REMARKS / ARGUMENTS

Appl. No. 10/645,966
Amdt. dated Jan. 28, 2005
Reply to Office action of Dec. 7, 2004

Appl. No. 10/645,966
Amdt. Dated Jan. 28, 2005
Reply to Office action of Dec. 7, 2004
Annotated Sheet Showing Changes

FIG.2

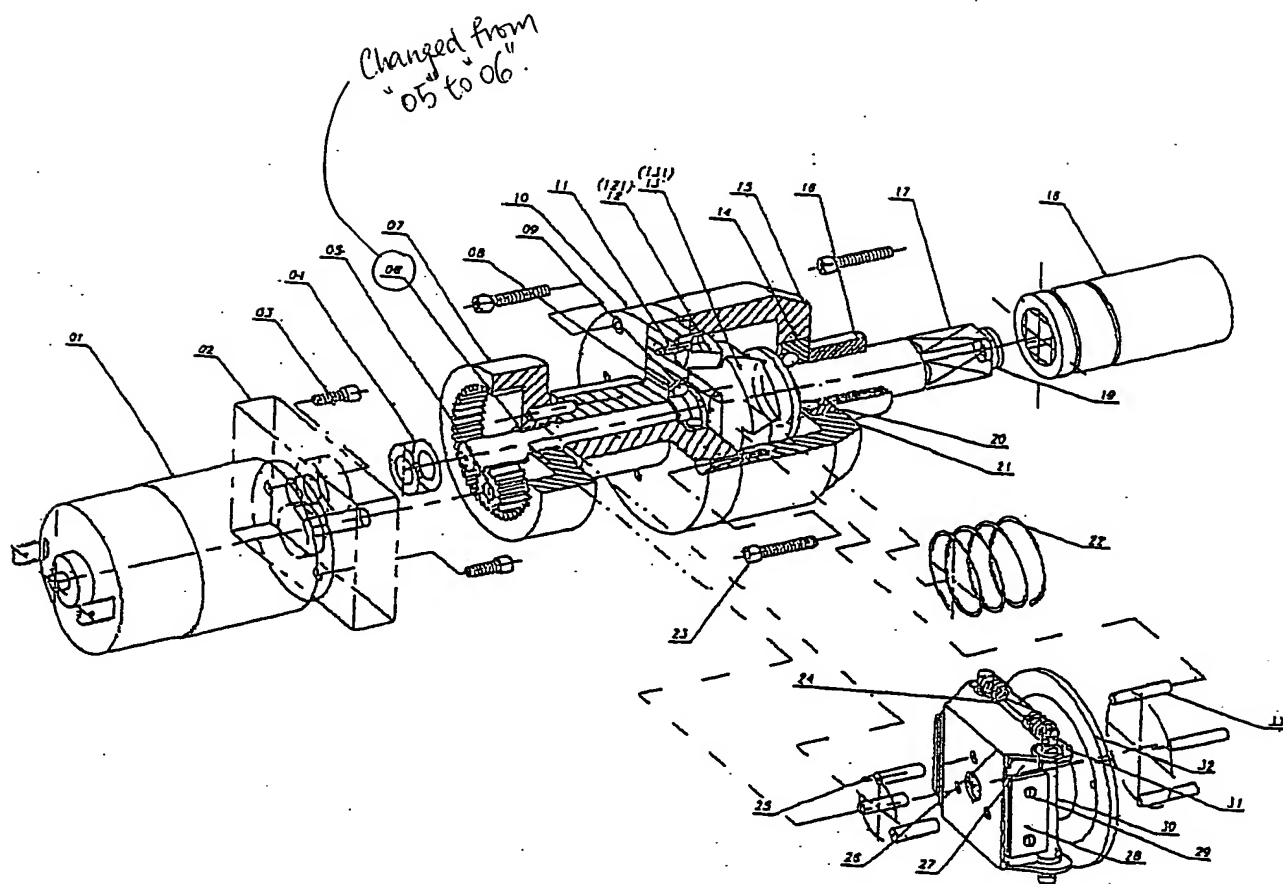
In amended Fig. 2, one of the original reference numbers 05 has been amended to 06.

The examiner also considers that the clutch bracket (6) is stated to have "at least one hole" in the claims and that from the drawings it appears that it can have only one hole, and thus the specification and claims are not supported by the drawings. Please kindly take note that the reference number for the clutch bracket should be (26) instead of (6). According to Fig. 2, there are 3 holes on the clutch bracket (26) for 3 set pins (25) to go through. It should be obvious to a person skilled in the art that the number of set pins can vary and thus the number of holes on the clutch bracket can also vary. Therefore, the drawings should be able to support the claim that the clutch bracket has at least one hole. I trust that your objection to my claim on the part of the clutch bracket should be a misunderstanding caused by the typo in the specification. I apologize for any inconvenience caused.

The attached sheet of drawings includes changes to Fig. 2. This sheet, which includes Fig. 2, replaces the original sheet including Fig. 2. In Fig. 2, one of the original reference numbers 05 is changed to 06.
